CUSTOMER ADVISORY

ADV2002

Label Content Update for FPGA and Power Products

Table 2: Label Sample with “RoHS COMPLIANT”

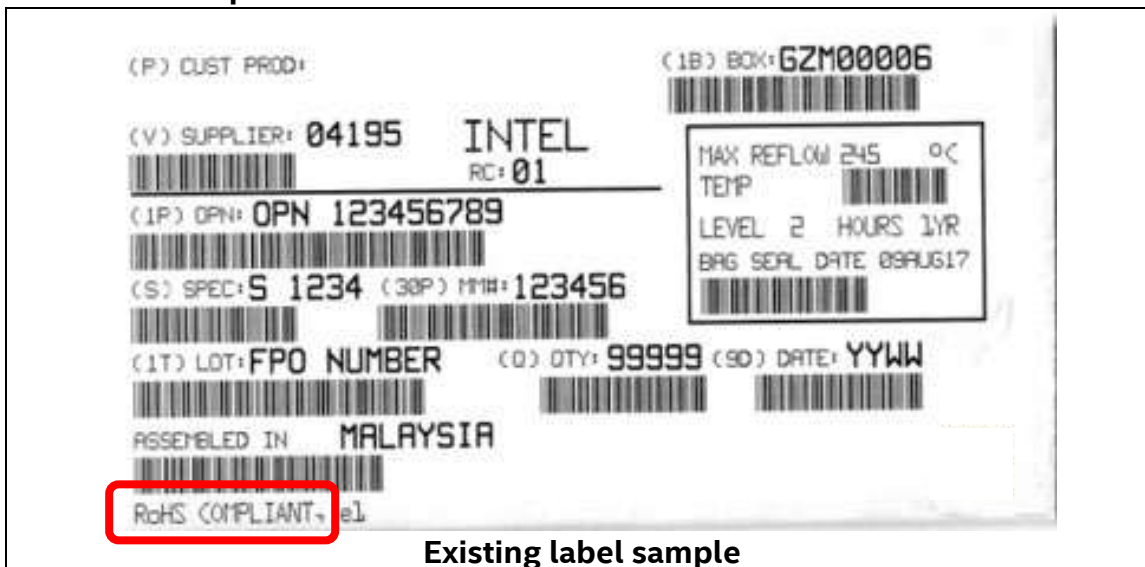
The label content change is to prevent displaying an inaccurate status of compliance to the EU Restriction of Hazardous Substances (RoHS) Directive during transition period due to the RoHS Exemption 15 scope change in February 29, 2020.

Change From	Change To
"RoHS COMPLIANT" indicated on the lower left of the barcode label	Labels may or may not indicate " RoHS COMPLIANT " on the barcode label. The 2nd level interconnect symbol (e.g. e1) remains printed on the label.
